Access Compliance Report

Public Rights-of-Way

(Pedestrian Signals)

Intersection ID: N/A	Main Street:	Cross Street: N/A	Location: N/A
ADA ID: 2427BD5A0373	Signal Type: Two Push Buttons-Non APS	Overall Compliance: No	Severity Score: BTN 1:N/A BTN 2: N/A No BTN: N/A
Codes/Mitigation Info/Possible Solution		Field Measurements/Component Compliance

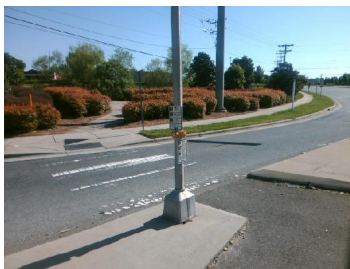
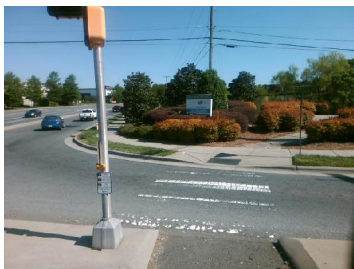
PROW/ADA: R404.2, R404.7.1, R404.7.2,
TMUTCD 4e.08

Compliance	Description	Data	Compliance	Description	Data
	Button Count	Button2	N/A	Distant to Additional Button (in)	N/A
	Additional Button Present?	No		Additional Button ID	N/A
N/A	Signal Buttons Required?	N/A	N/A	Additional Ped Posts Required	N/A
	How Many Ped Street Xings?	3		Located In An Island/Median?	Yes
N/A	B 1 Sign Present?	Yes	N/A	B 2 Sign Present?	Yes
Yes	B 1 Sign Purpose?	Yes	Yes	B 2 Sign Purpose?	Yes
Yes	B 1 Sign Lettering & Contrast?	Yes	Yes	B 2 Sign Lettering & Contrast?	Yes
Yes	B 1 Parallel To XWalk?	Yes	Yes	B 2 Parallel To XWalk?	Yes
Yes	B 1 PAR to Button?	Yes	Yes	B 2 PAR to Button?	Yes
Yes	B 1 PAR to XWalk?	Yes	Yes	B 2 PAR to XWalk?	Yes
Yes	B 1 Clear Floor Space?	Yes	Yes	B 2 Clear Floor Space?	Yes
No	B 1 FWD Approach?	No	No	B 2 FWD Approach?	No
N/A	B 1 FWD Approach Constrained?	No	N/A	B 2 FWD Approach Constrained?	No
N/A	B 1 FWD Approach Reach (in)	N/A	N/A	B 2 FWD Approach Reach (in)	N/A

N/A	B 1 FWD Approach Width (in)	N/A	N/A	B 2 FWD Approach Width (in)	N/A
N/A	B 1 FWD Approach Obstruction?	Yes	N/A	B 2 FWD Approach Obstruction?	Yes
N/A	B 1 FWD Approach Obstruction Dist (in)	4.0	N/A	B 2 FWD Approach ObstructionDist (in)	6.0
No	B 1 PARA Approach?	No	No	B 2 PARA Approach?	No
N/A	B 1 PARA Approach Constrained?	No	N/A	B 2 PARA Approach Constrained?	No
N/A	B 1 PARA Approach Reach (in)	28.0	N/A	B 2 PARA Approach Reach (in)	28.0
N/A	B 1 PARA Approach Width (in)	60.0	N/A	B 2 PARA Approach Width (in)	60.0
N/A	B 1 PARA Approach Obstruction?	Yes	N/A	B 2 PARA Approach Obstruction?	Yes
N/A	B 1 PARA Approach Obstruction Dist (in)	4.0	N/A	B 2 PARA Approach ObstructionDist (in)	6.0
Yes	B 1 Clear Floor Space Slope (%)	1.6	Yes	B 2 Clear Floor Space Slope (%)	1.6
No	B 1 Clear Floor Space XSlope (%)	2.3	No	B 2 Clear Floor Space XSlope (%)	2.3
N/A	B 1 PAR Slope (%)	2.5	N/A	B 2 PAR Slope (%)	2.5
Yes	B 1 Height (in)	48.0	Yes	B 2 Height (in)	48.0

Possible Solutions: Provide Clear Space.
Replace Signal Push Button With APS Button
on New Post. Remove & Relocate Sign.
